[Docket No. FAA-2012-0415; Directorate Identifier 2008-SW-065-AD; Amendment 39-17865; AD 2014-12-04]

Airworthiness Directives; Bell Helicopter Textron, Inc. (BHTI) Helicopters

ACTION: Final rule.

Figure 1 to Paragraphs (f)(2)(ii) and (f)(4)(ii)
Inspection of Main Rotor Hub Grip Tangs

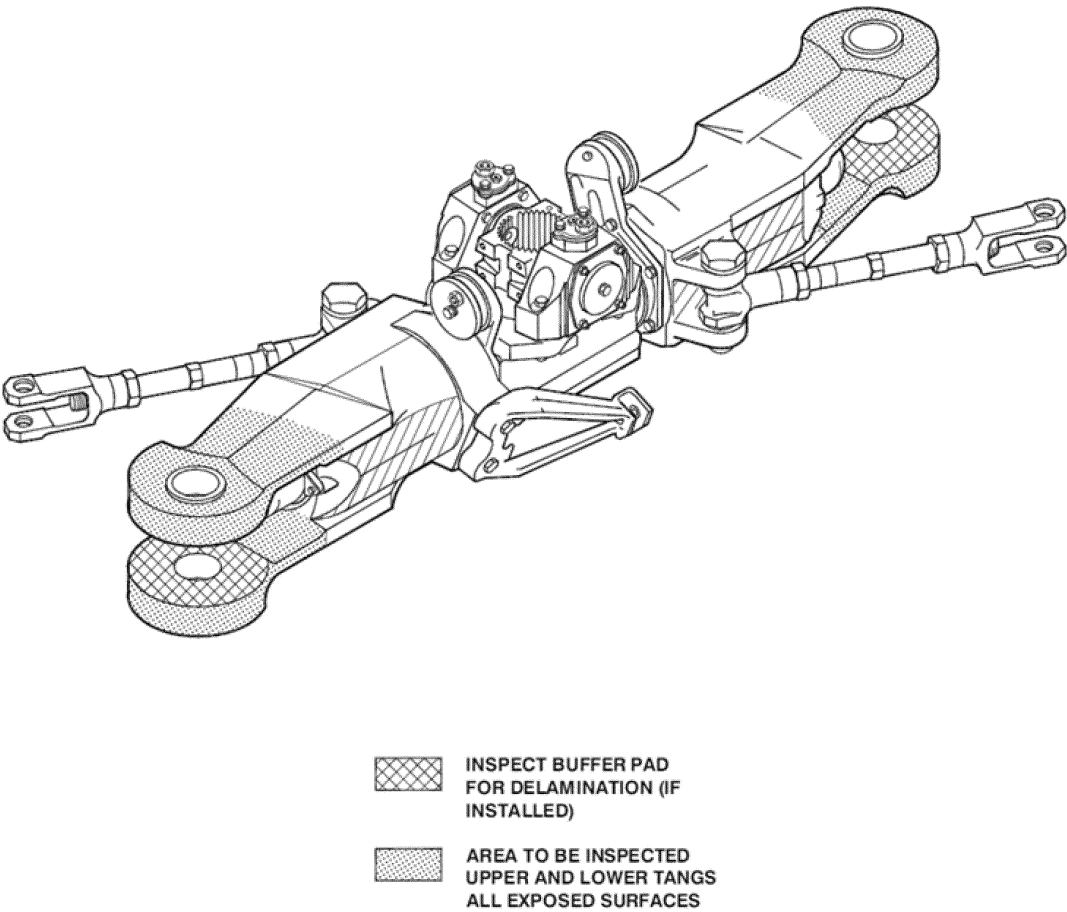
- (ii) Using a 10-power or higher magnifying glass, visually inspect the exposed surfaces of the upper and lower tangs of each grip for a crack. Pay particular attention to the lower surface of each lower grip tang from the main rotor blade bolt-bushing flange to the leading and trailing edge of each grip tang as depicted in Figure 1 to Paragraphs (f)(2)(ii) and (f)(4)(ii) of this AD.

(ii) Inspect each grip buffer pad on the inner surfaces of each grip tang for delamination as depicted in Figure 1 to Paragraphs (f)(2)(ii) and (f)(4)(ii) of this AD. If there is any delamination, remove the buffer pad and inspect the grip surface for corrosion or other damage.
